MSC.1/Circ.1197  
6 June 2006

**AMENDMENTS TO THE UNIFIED INTERPRETATIONS TO SOLAS CHAPTERS II-1  
AND XII APPROVED BY MSC/CIRC.1176**

**AMENDMENTS TO THE UNIFIED INTERPRETATIONS TO SOLAS CHAPTERS II-1  
AND XII APPROVED BY MSC/CIRC.1176****1.1 SOLAS REGULATION II-1/3-6, SECTION 1****Technical background**

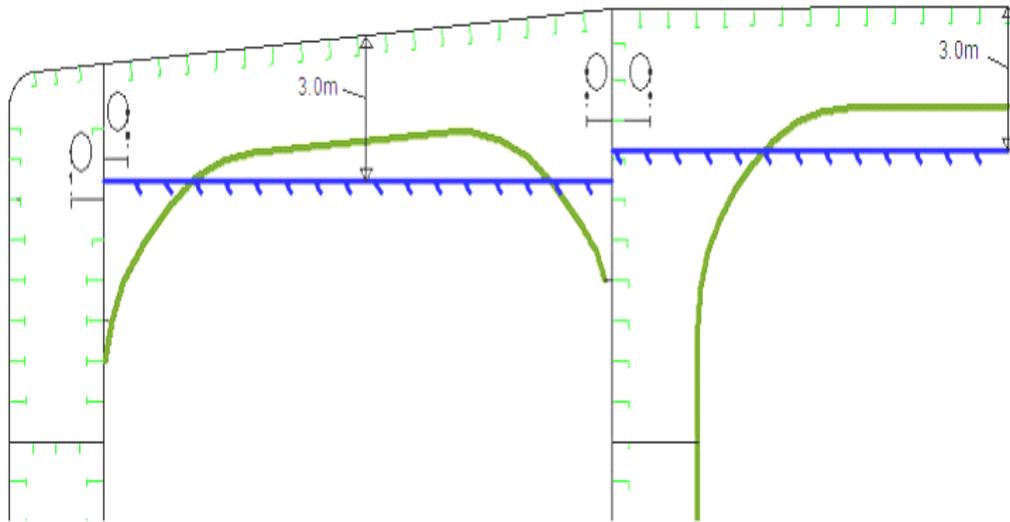
- 1 The last sentence of the technical background is replaced by the following:

“Regulation II-1/3-6 is applicable to new, purpose-built FPSO or FSU if they are subject to the scope of the ESP Guidelines (resolution A.744(18), as amended). Considering that the principles of the Technical provisions for means of access for inspections (resolution MSC.158(78)) recognize that permanent means of access should be considered and provided for at the design stage so that, to the maximum extent possible, they can be made an integral part of the designed structural arrangement, regulation II-1/3-6 is not considered applicable to an FPSO/FSU that is converted from an existing tanker.”
